Residential Appeals Committee

STAFF REPORT

Case File Number: APL19-017 (PLN18-513)

Location:	Vacant Parcel located between 6303 and 6311 Wood Drive (See map on reverse)
Assessors Parcel Number:	048C-7179-023-00
Proposal:	Appeal of the Zoning Manager's Administrative Approval of a Regular Design Review application to construct a new hillside single-family residence.
Appellants:	Kim Cardoso / (415) 505-0165 and Michael Steel / (415) 260-7320
Applicant:	John Newton / (510) 847-4108
Planning Permits Required:	Regular Design Review to construct a new residential single family dwelling unit on a vacant parcel.
General Plan:	Hillside Residential
Zoning:	RH-4 (Hillside Residential – Zone 4) S-9 Fire Protection Safety Combining Zone
Environmental Determination:	15303-new construction of small structures; and 15183-Projects Consistent with a Community Plan, General Plan or Zoning
Historic Status:	OCHS Rating: Non-Historic Property
City Council District:	4
Status:	Application Approved by the Zoning Manager on April 11, 2019 and subsequently Appealed on April 22, 2019

Figure 1 - Existing Canopy at Subject Property

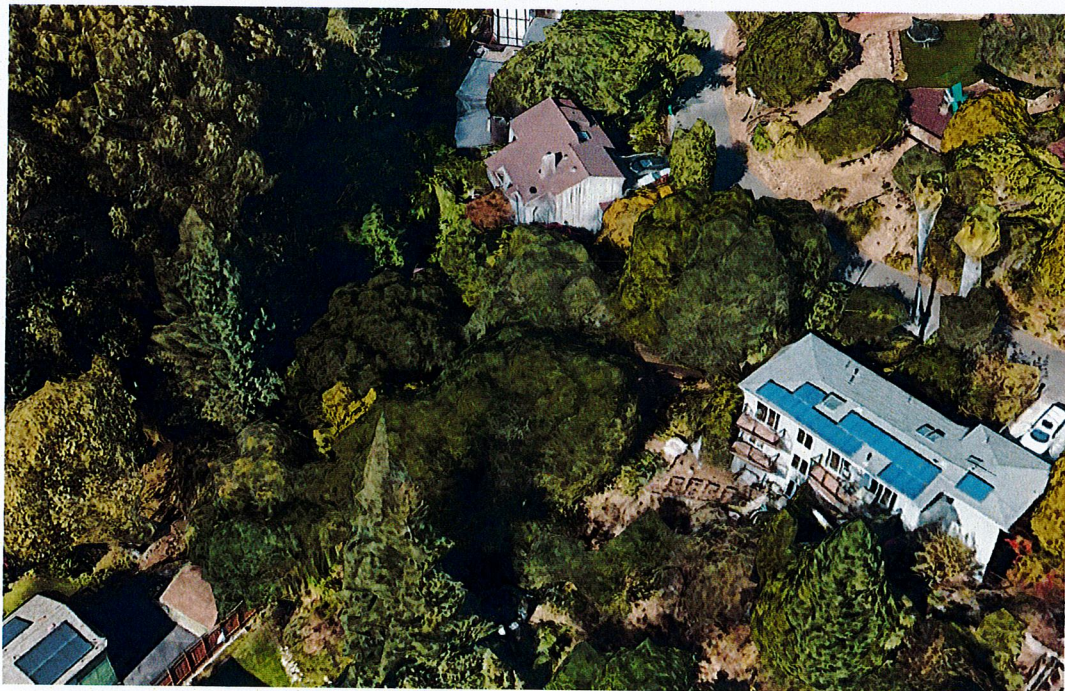
1. ***Privacy*** – *That the proposed project’s main living areas (lower-floor) and master bedroom (upper floor) are oriented in a manner that do not minimize privacy impacts on the Appellant’s outdoor patio, garden, master bedroom, and office.*

Staff’s Response: Staff has worked with the applicant to address the privacy issue by reducing the size of the upper-floor windows and providing obscure glass as prescribed by the applicable guidelines. Furthermore, privacy concerns are sufficiently addressed because there will not be direct casual views into the adjacent neighbor at 6311 Wood Drive as the upper-floor bedroom windows are offset as suggested by the Guidelines and stepped back approximately 30 feet and 40 feet from the neighbor’s yard and side-facing windows at 6311 Wood Drive. Additionally, privacy impacts are further reduced with the existing dense landscaping between the residences. Figure 1 on the following page, a Google Earth image, shows the existing dense tree canopy on the subject site and 6311 Wood Drive to the east (left) of the subject vacant parcel. It is important to note that the Applicant has located and designed the home so as to protect all existing mature trees, with the exception of one tree on the western portion of the subject property that would be removed.

Figure 7 - Massing at Front Elevations (Left: 6311 Wood Dr, Center: Subject Parcel, Right: 6303 Wood Dr)

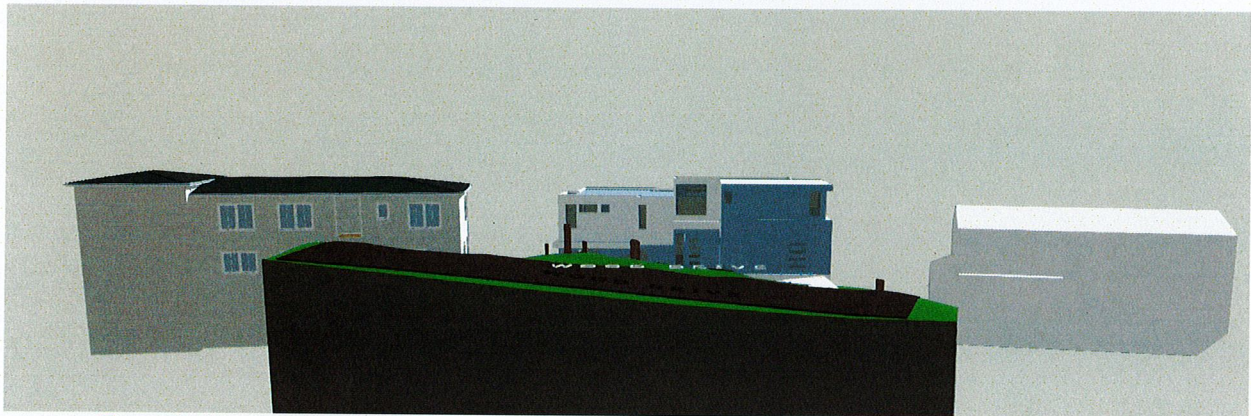
The project meets the guidelines. As shown in the approved plans (Attachment C) and Figures 6 and 7 on the following page, the building’s massing is proportionate to the Appellants’ homes. The building steps with the downslope terrain and the multiple volumes have staggered setbacks at the front and along the sides of the structure. Furthermore, the tapered building footprint with increased side yard setbacks beyond what the Zoning requires maintains openness between the home and the Appellants’ properties. In addition to the multiple volumes and stepped-back building footprint, the project incorporates modest projections and overhangs as well as recessed openings to provide strong shadow patterns to further reduce the bulk of the structure and provide visual interest.

**EAST ELEVATION OF 6303 WOOD DRIVE
FACING THE PROJECT**

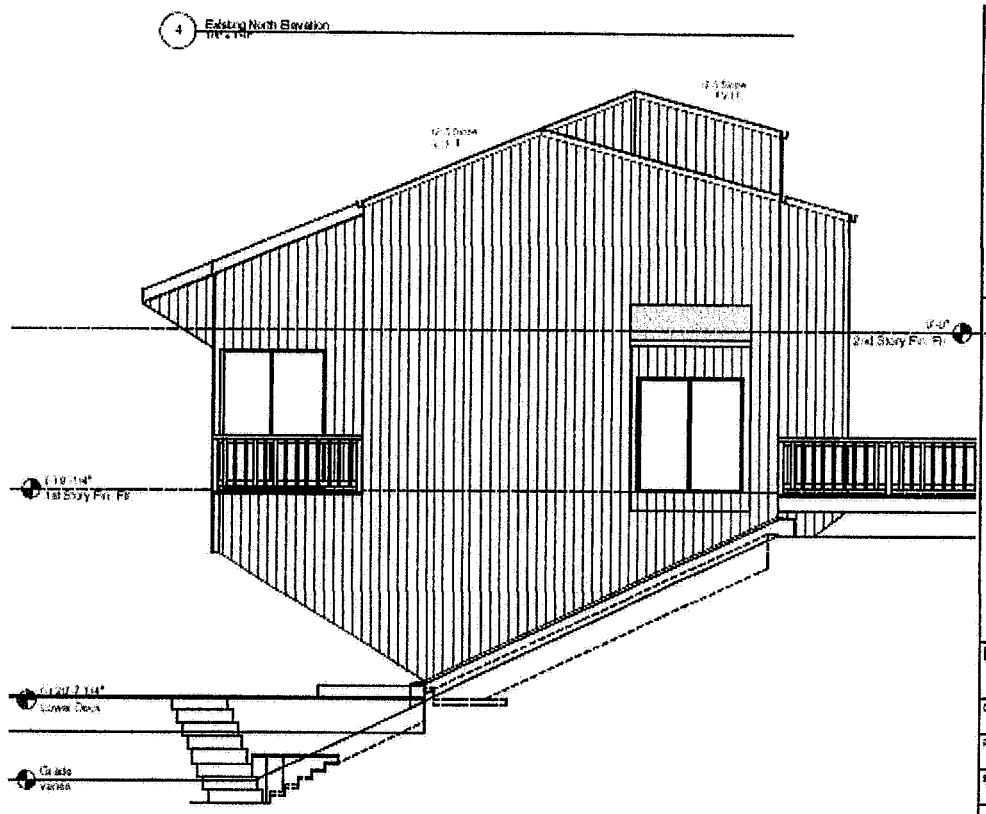
As a preliminary matter, the site plan for the Project is incorrect. First, it does not reflect the actual location or configuration of my home at 6303 Wood Drive. Second, I believe it misstates the distances between 6303 Wood Drive and the Project. Third, I believe that it does not accurately depict the site contours between 6303 Wood Drive and the Project. With respect to the last inaccuracy, it appears not to recognize the significant slope between the two properties. These inaccuracies mask several significant design defects in the Project.

PRIVACY IMPACTS
Corrected site plan and sight lines

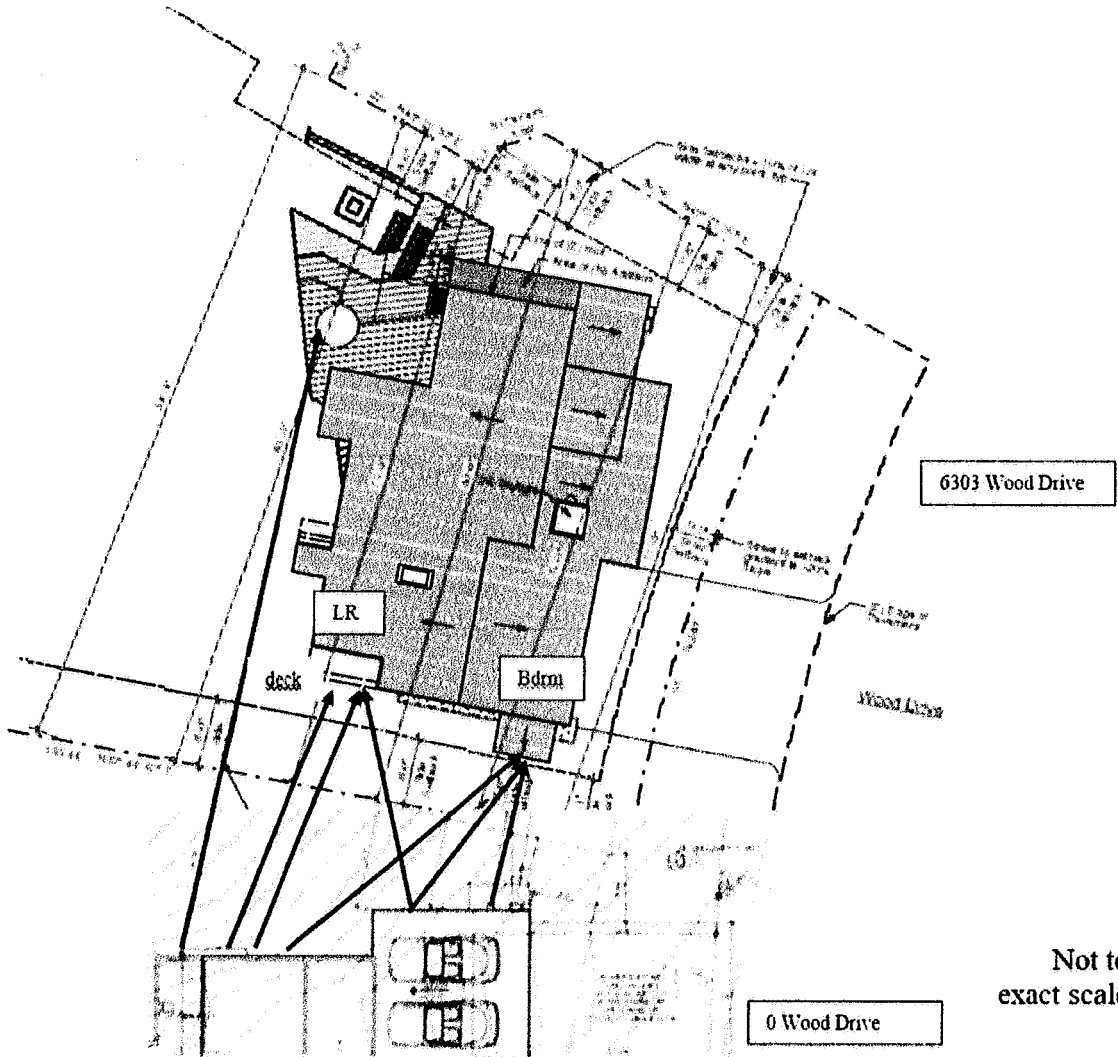
Per section 3.3A and 3.3D, the new construction must reduce sight lines to my impacted primary living areas. Measures could include changed orientation of the home or floor plan, fewer windows, reduced window size, and privacy glazing.

WINDOWS TO BE ELIMINATED OR CONVERTED TO CLERESTORY
Remaining windows to conform to 5' from floor guideline

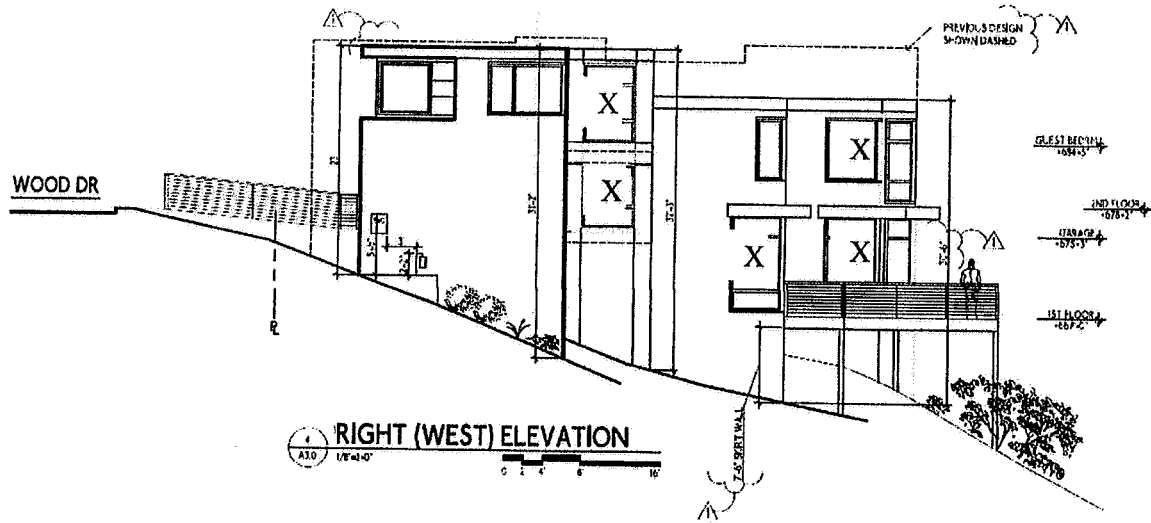
We had hoped to that, by pointing out these issues, the applicant would meet with us to modify the Project. Unfortunately, the applicant has been completely unwilling to make any change beyond frosting one of the *ten windows* looking into the bedroom and living room of my home.

Figure 1 - Existing Canopy at Subject Property

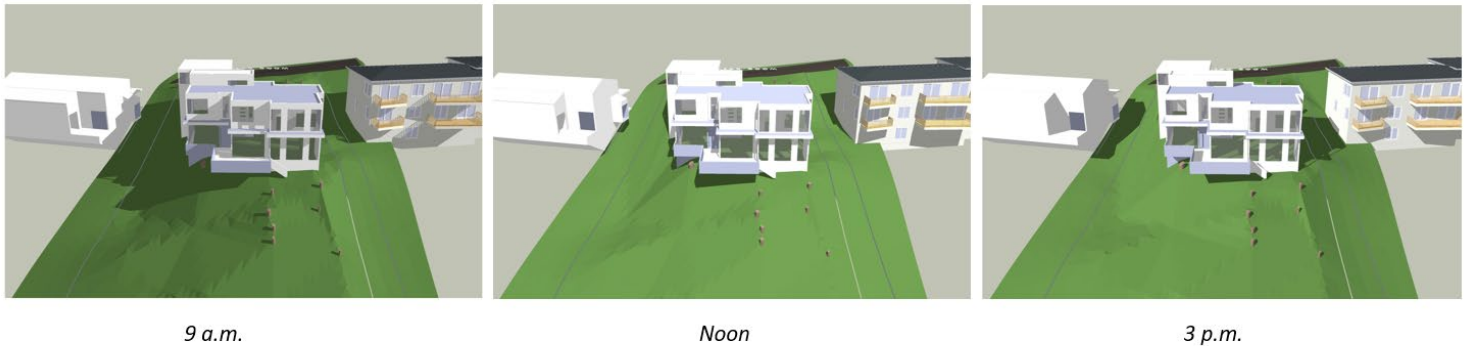
- 1. Privacy*** – That the proposed project’s main living areas (lower-floor) and master bedroom (upper floor) are oriented in a manner that do not minimize privacy impacts on the Appellant’s outdoor patio, garden, master bedroom, and office.

Staff’s Response: Staff has worked with the applicant to address the privacy issue by reducing the size of the upper-floor windows and providing obscure glass as prescribed by the applicable guidelines. Furthermore, privacy concerns are sufficiently addressed because there will not be direct casual views into the adjacent neighbor at 6311 Wood Drive as the upper-floor bedroom windows are offset as suggested by the Guidelines and stepped back approximately 30 feet and 40 feet from the neighbor’s yard and side-facing windows at 6311 Wood Drive. Additionally, privacy impacts are further reduced with the existing dense landscaping between the residences. Figure 1 on the following page, a Google Earth image, shows the existing dense tree canopy on the subject site and 6311 Wood Drive to the east (left) of the subject vacant parcel. It is important to note that the Applicant has located and designed the home so as to protect all existing mature trees, with the exception of one tree on the western portion of the subject property that would be removed.

Figure 6 - Massing at Rear Elevations (Left: 6303 Wood Dr, Center: Subject Parcel; Right: 6311 Wood Dr)

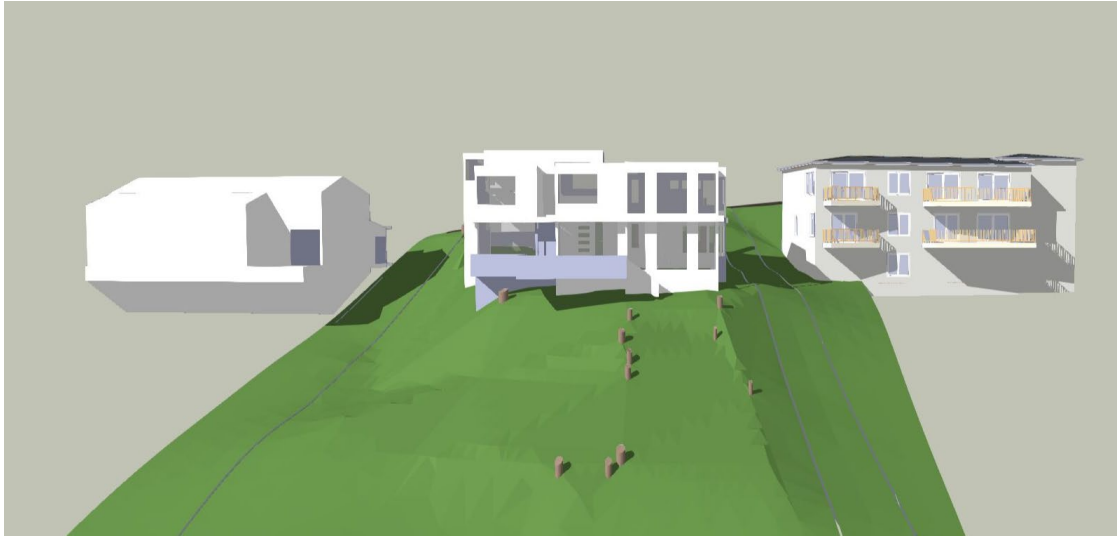
The project meets the guidelines. As shown in the approved plans (Attachment C) and Figures 6 and 7 on the following page, the building’s massing is proportionate to the Appellants’ homes. The building steps with the downslope terrain and the multiple volumes have staggered setbacks at the front and along the sides of the structure. Furthermore, the tapered building footprint with increased side yard setbacks beyond what the Zoning requires maintains openness between the home and the Appellants’ properties. In addition to the multiple volumes and stepped-back building footprint, the project incorporates modest projections and overhangs as well as recessed openings to provide strong shadow patterns to further reduce the bulk of the structure and provide visual interest.
